Man's Attires Ltd. (10792)

Hosiery Ind. Estate, Pl. A-87, Eyanet Nagar, Fatullah, Naranganj

26.05.2014

Identified Priority 1 Concerns

2nd Priority 1 Concern: Presence of heavy loads

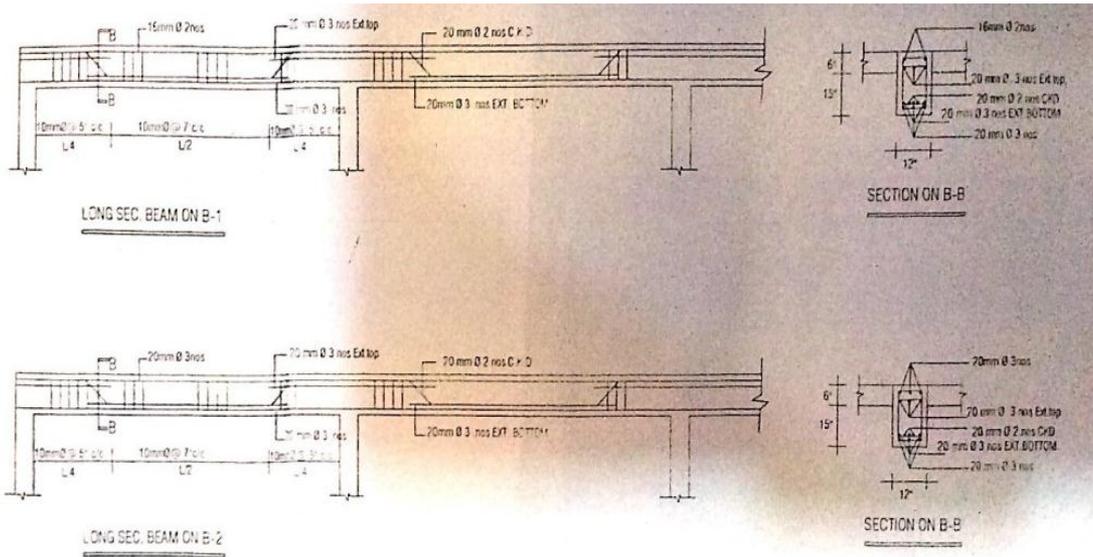
At several locations throughout the building, large superimposed loads due to storage, material wastage, or heavy partitions are noted. These loads should be evacuated down to 2.0 kPa. Furthermore, unless the DEA confirms the capacity of the structure, heavy partitions should be removed and replaced by lightweight construction.
